Addendum No. 03

PROJECT: PRESIDENT WOODROW WILSON HOUSE BUILDING SYSTEMS IMPROVEMENTS

DATE: JULY 27, 2026

RE: ADDENDUM NO. 3 TO REQUEST FOR PROPOSAL 2026-09, ISSUED JULY 6, 2026

1 BASEMENT - MECHANICAL - NEW WORK PLAN
M-100 1/4" = 1'-0"

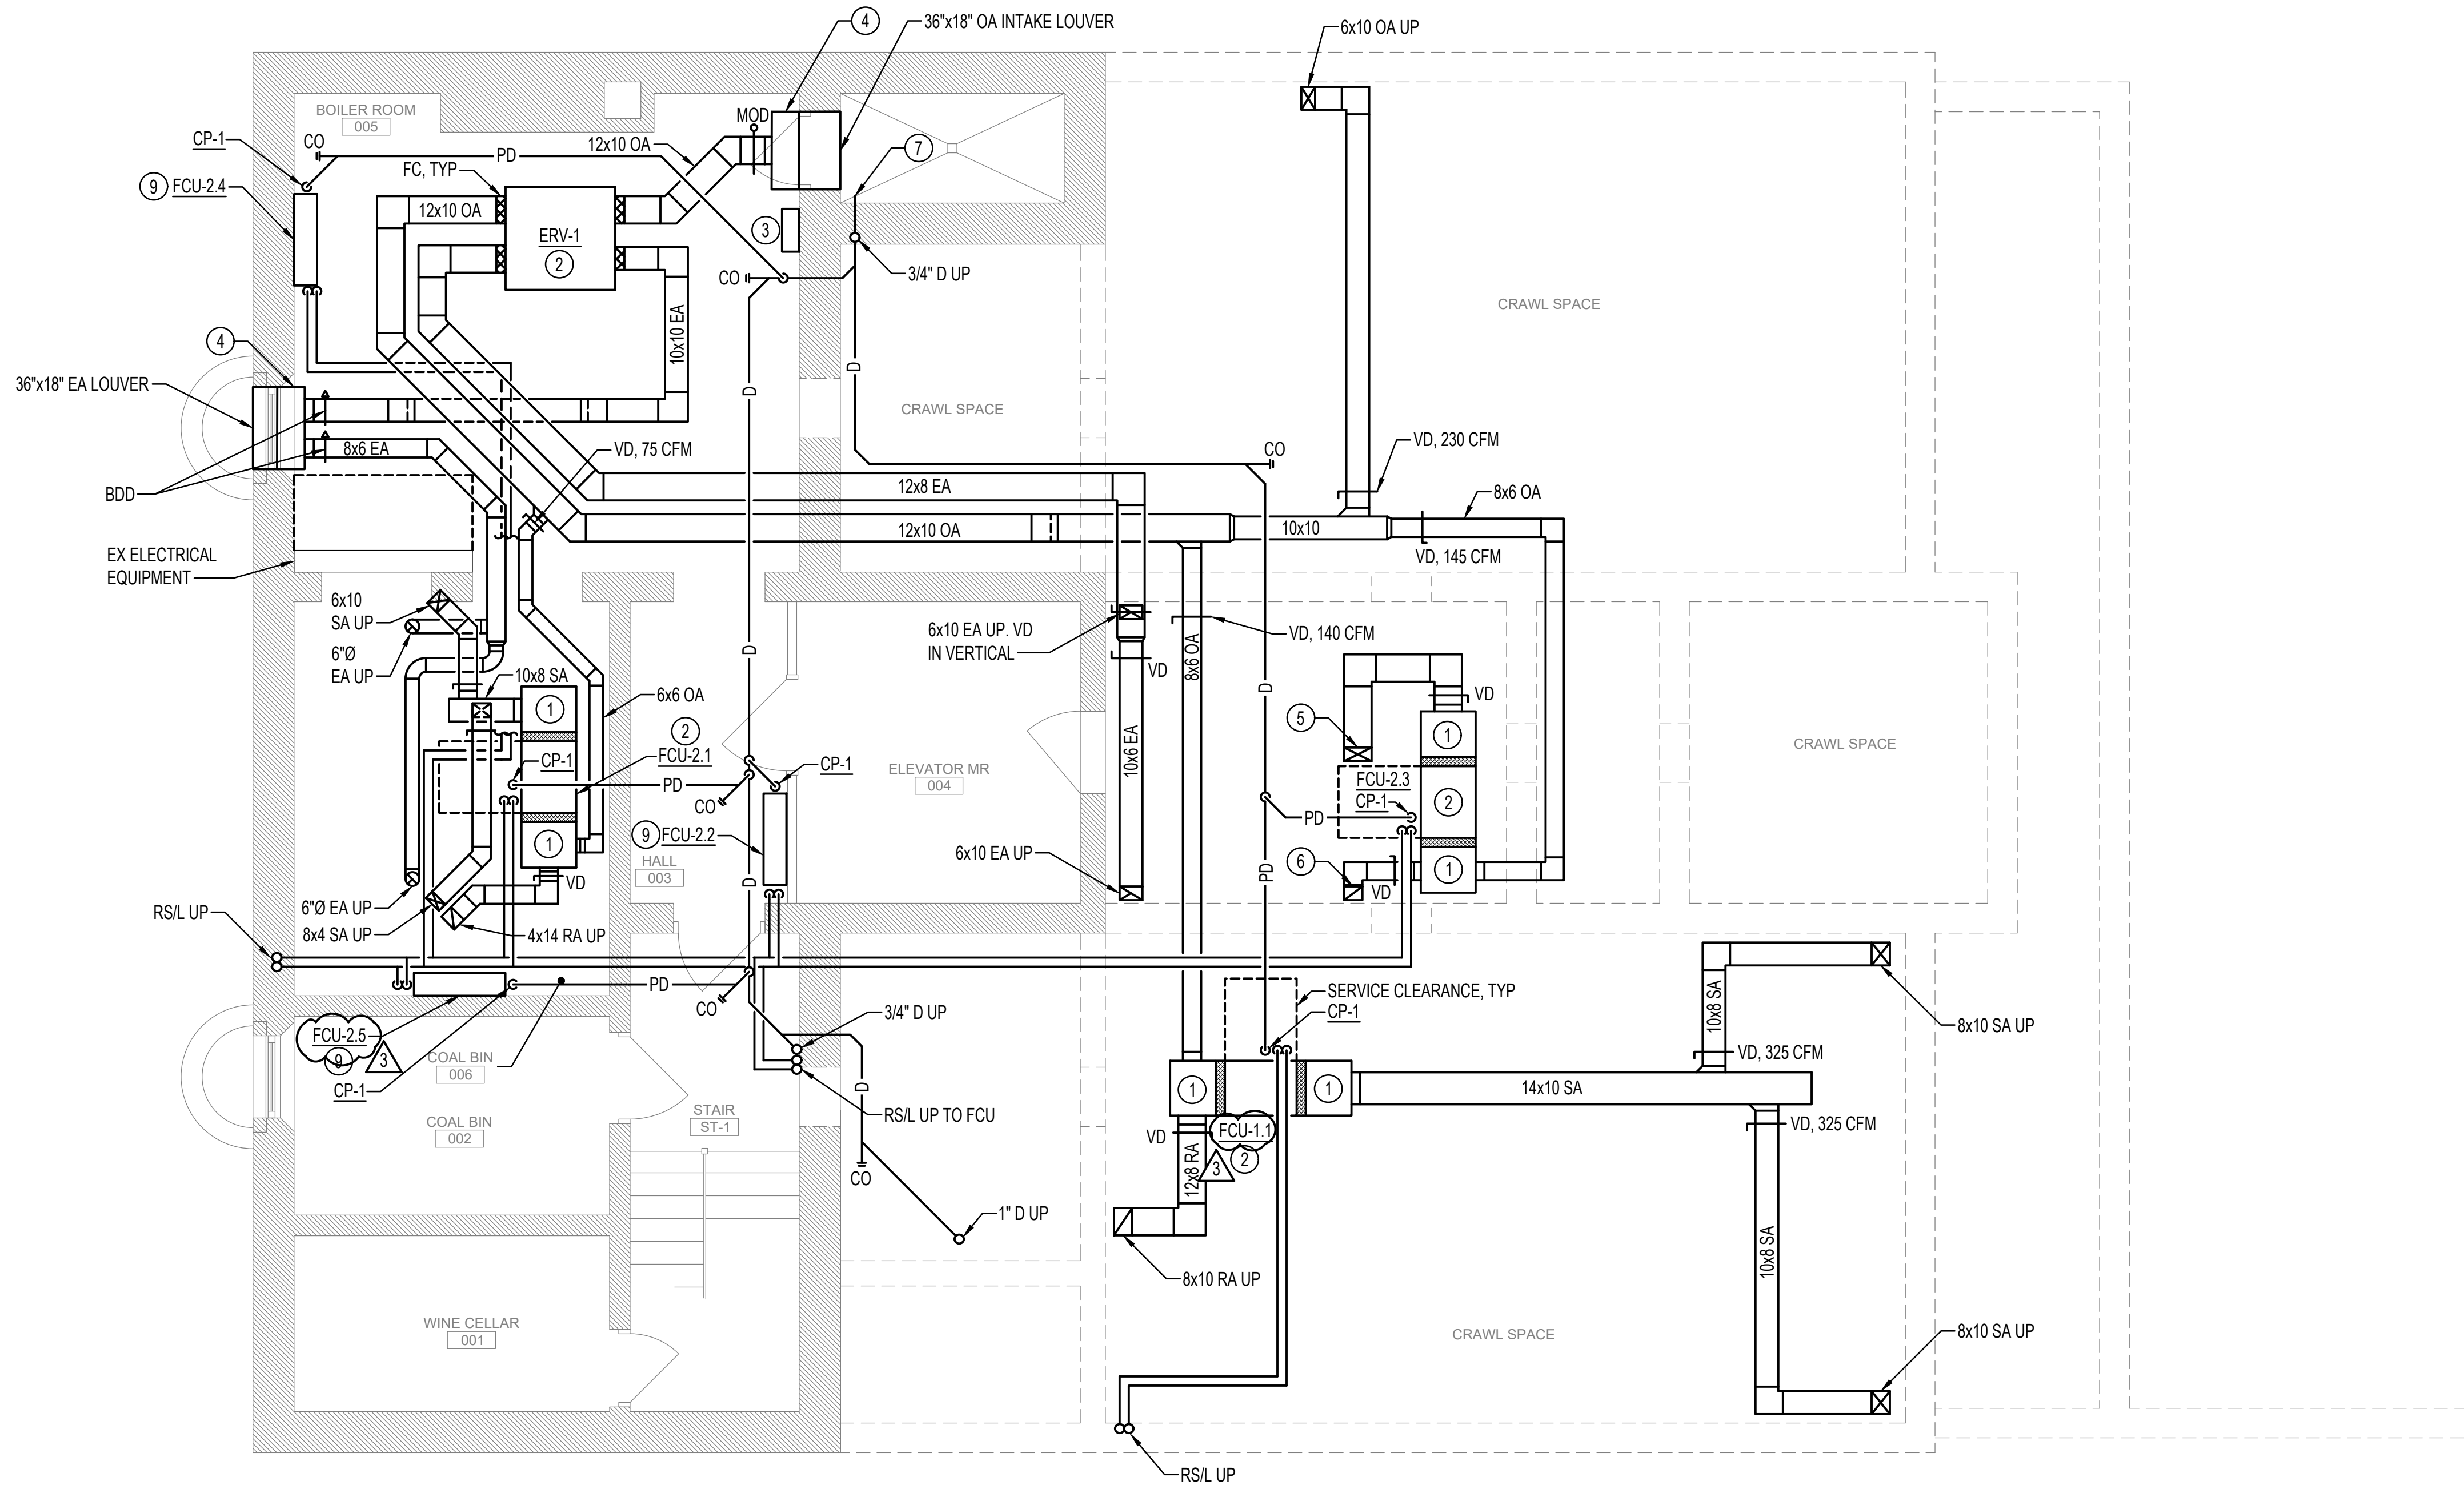
1. SHEET M-100 BASEMENT – MECHANICAL – NEW WORK
 - a. Update FCU designations per revised sheet.
2. SHEET M-101 FIRST FLOOR – MECHANICAL – NEW WORK
 - a. Update FCU designations per revised sheet.

1 SECOND FLOOR - MECHANICAL - NEW WORK PLAN
M-102 / 1/4" = 1'-0"

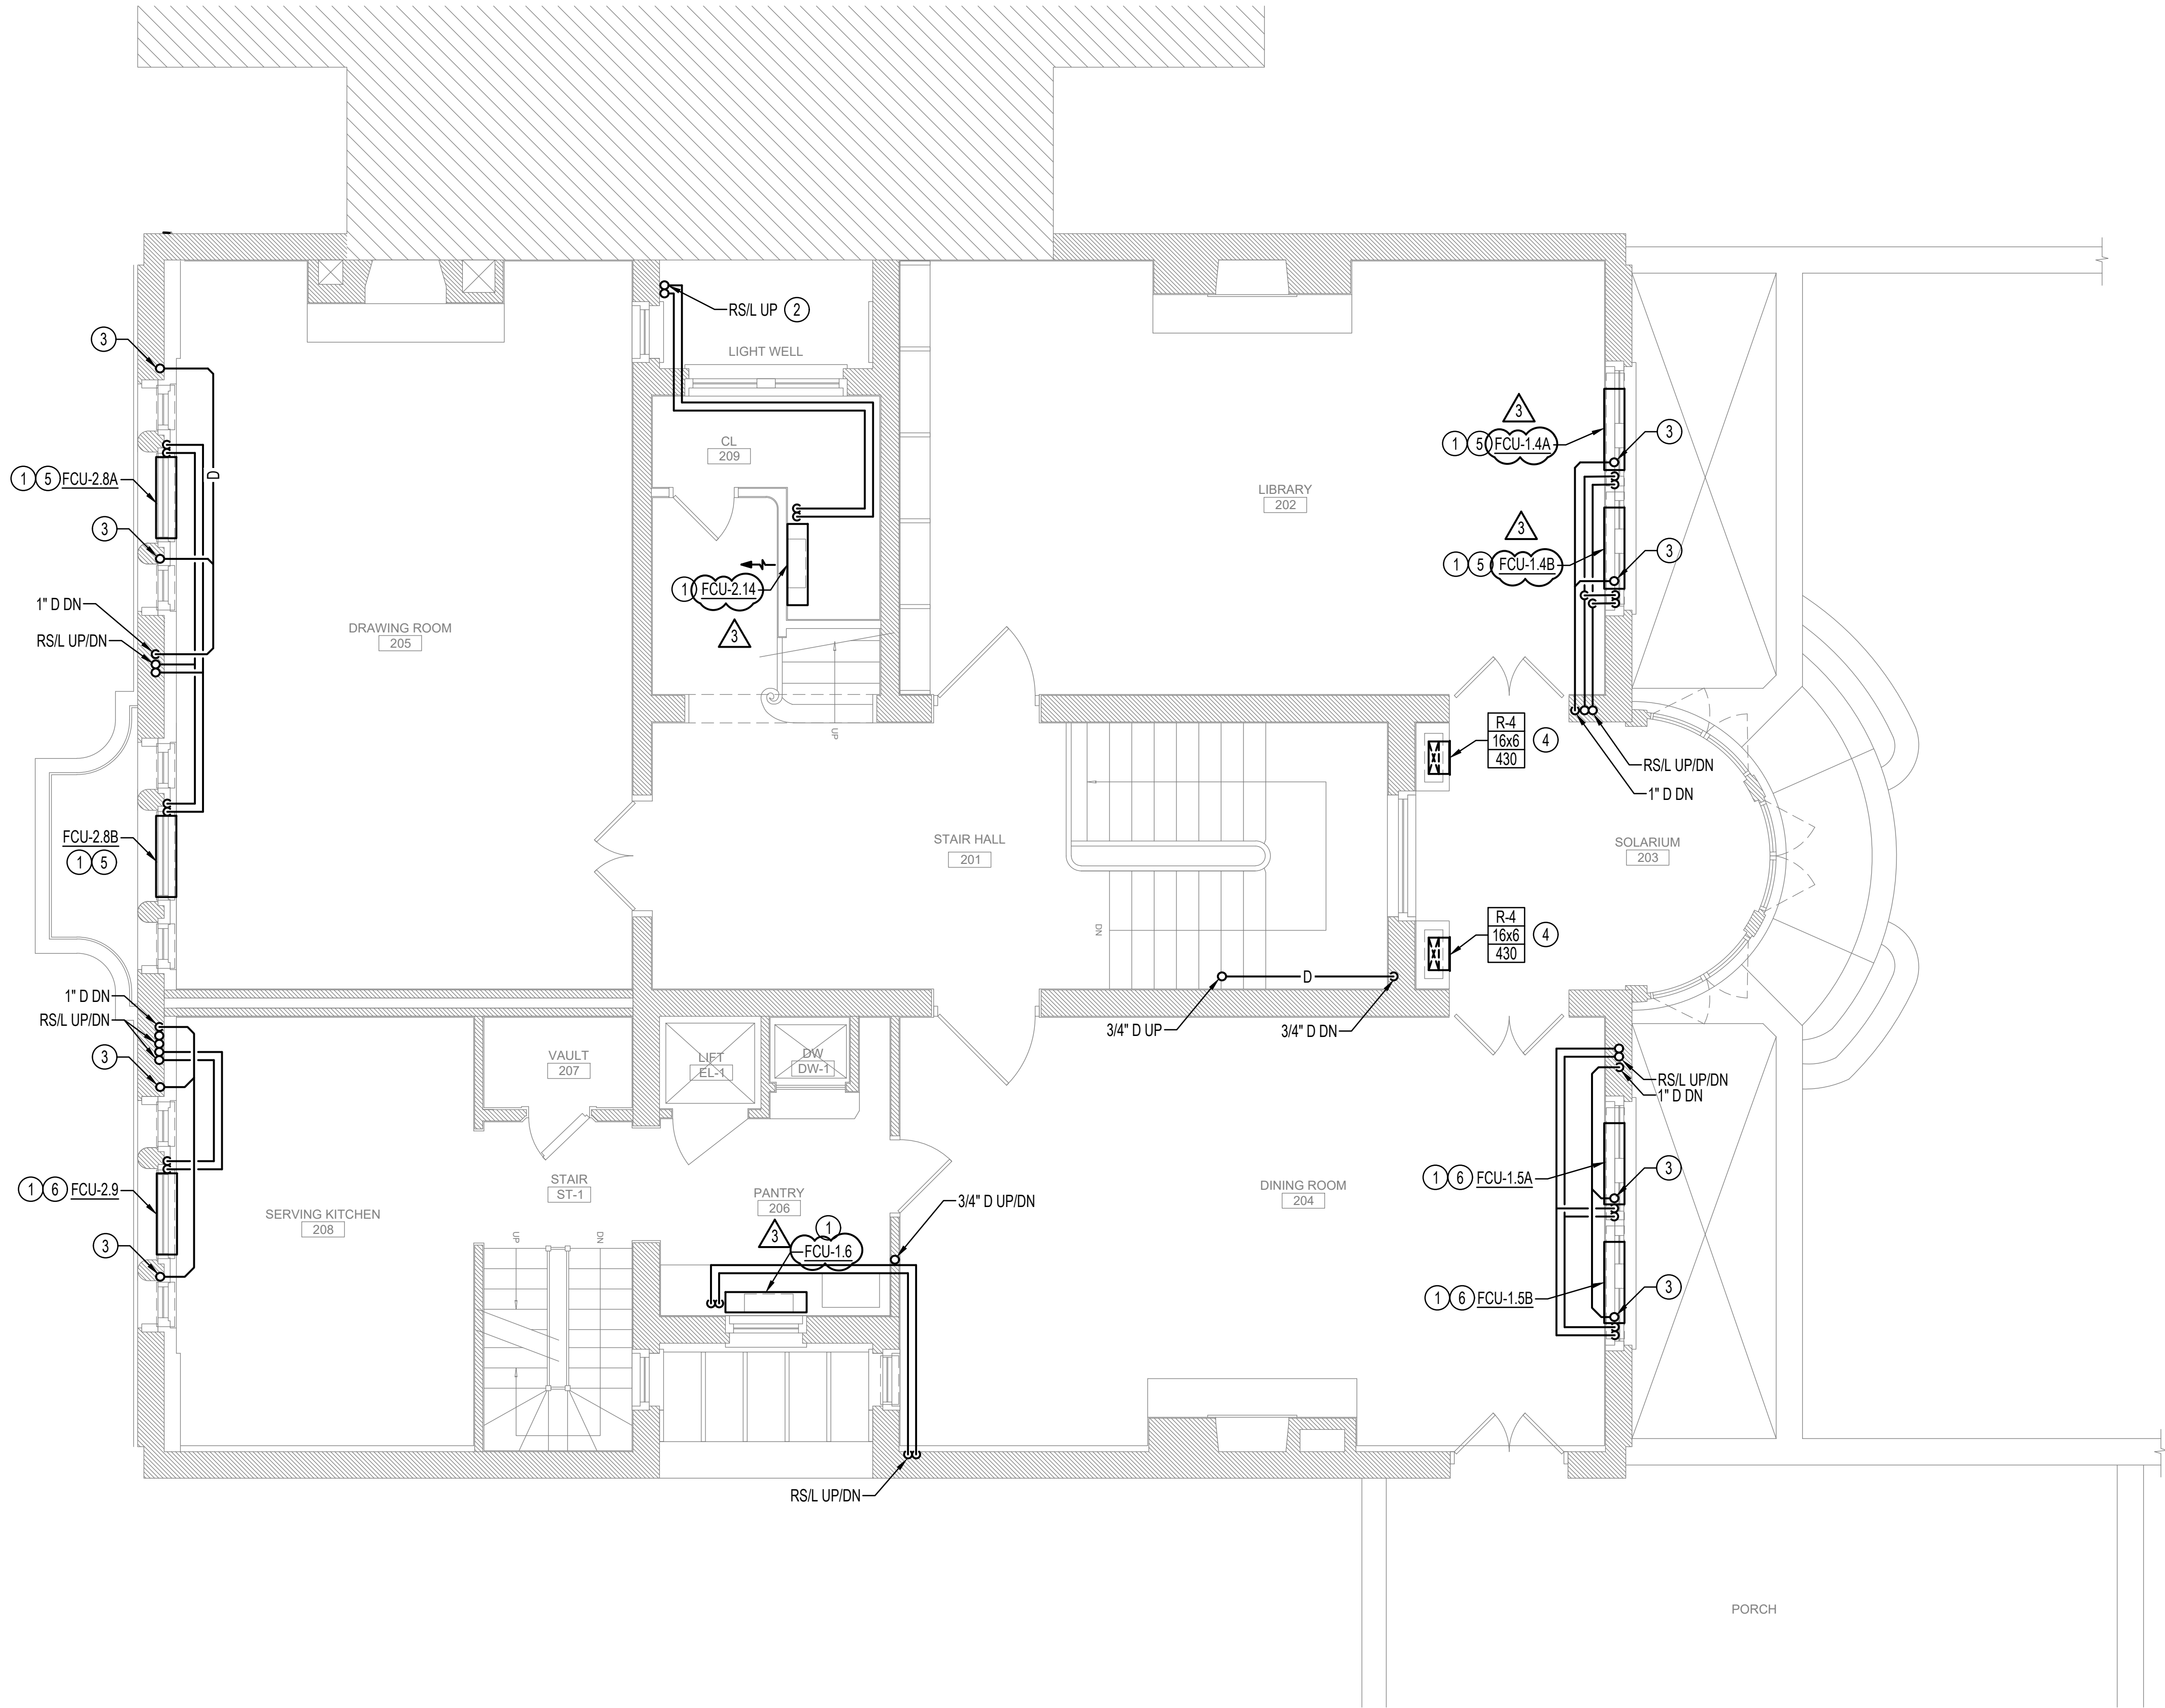
3. SHEET M-102 SECOND FLOOR - MECHANICAL – NEW WORK
 - a. Update FCU designations per revised sheet.
4. SHEET M-103 THIRD FLOOR – MECHANICAL – NEW WORK
 - a. Update FCU designations per revised sheet.

1
M-104
FOURTH FLOOR - MECHANICAL - NEW WORK PLAN
1/4" = 1'-0"

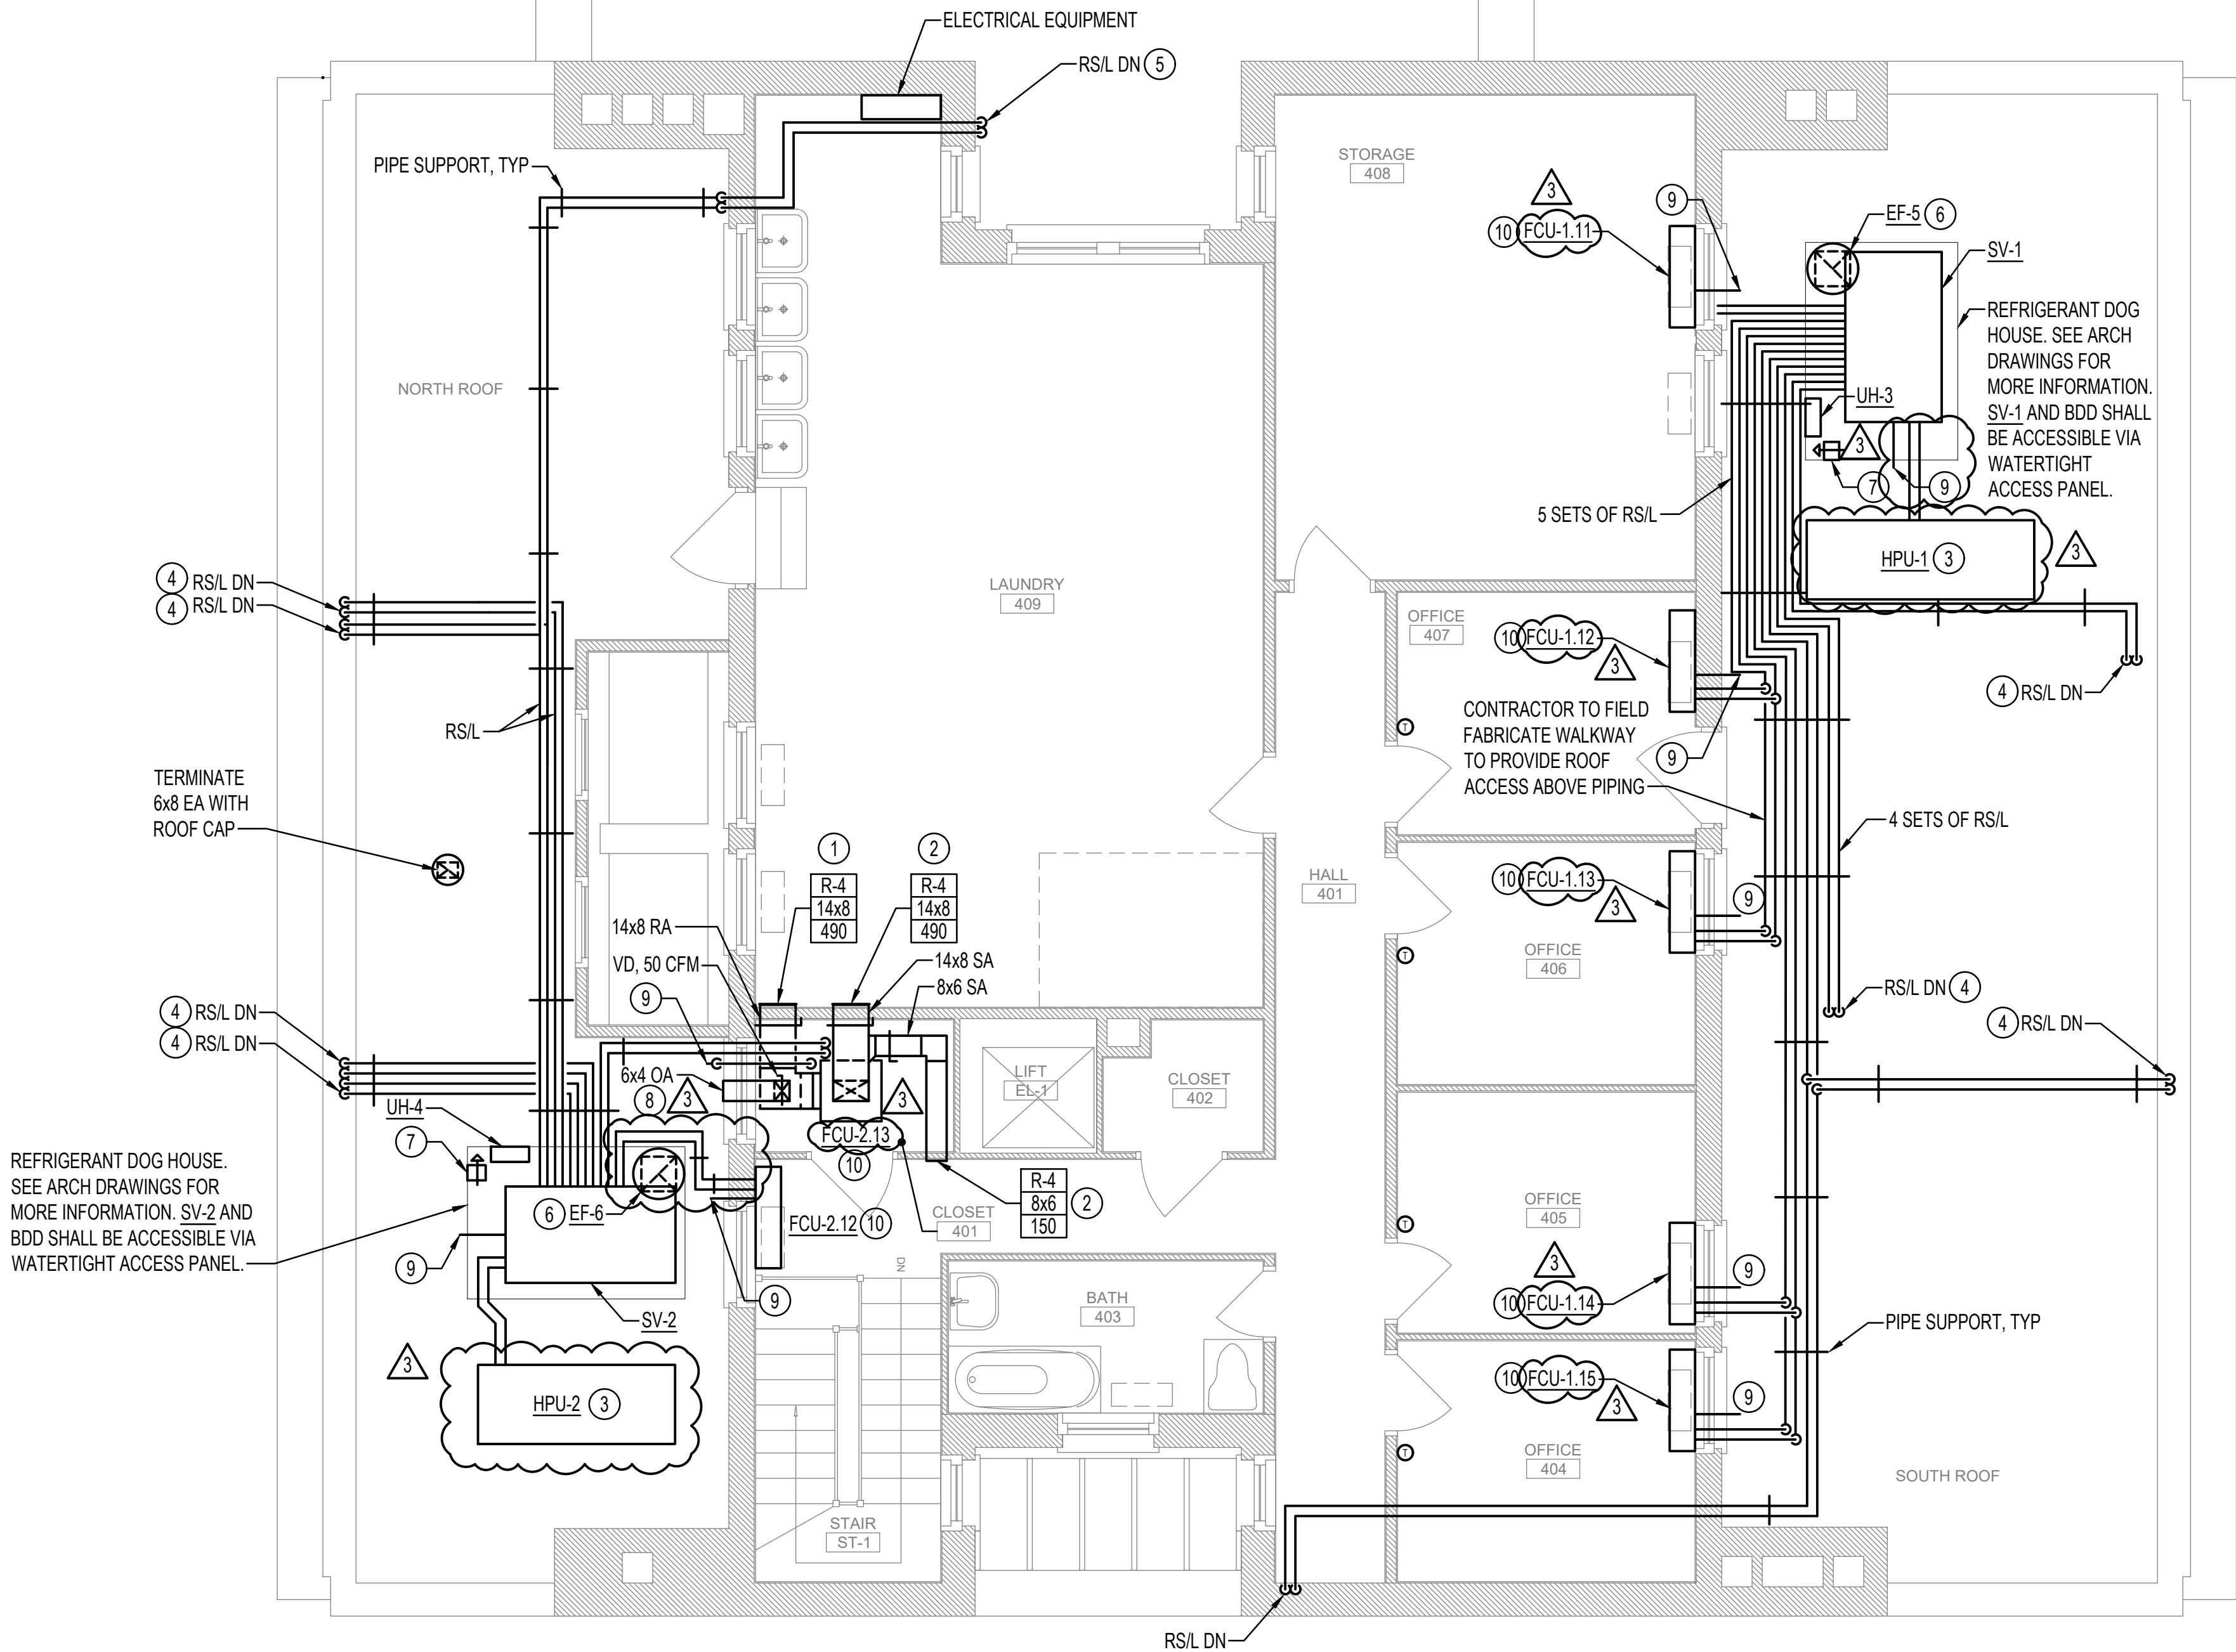
Q1: Please clarify the scope and design of the rooftop refrigerant shutoff valve enclosures noted on A-104 and M-104.

5. SHEET M-104 FOURTH FLOOR – MECHANICAL – NEW WORK
 - a. Update FCU designations per revised sheet.
 - b. Updated HPU-1 and HPU-2 footprint as noted.
6. SHEET M-601 CONDENSATE RISER DIAGRAMS

A: Exact design of the enclosures will be determined in coordination with the selected contractor. For bidding purposes, contractors should include an allowance, as follows:

3. Allowance No. 1 – Rooftop Refrigerant Shutoff Valve Enclosure

Bidders shall include a Stipulated Allowance of **\$10,000.00** in the Total Base Bid for the fabrication, supply, and installation of two (2) rooftop refrigerant shutoff valve enclosures to satisfy requirements, as noted on drawings A-104 Plan Keynote "24" and M-104. Specific design and requirements for these enclosures will be determined in consultation with the selected contractor during the pre-construction period of work.
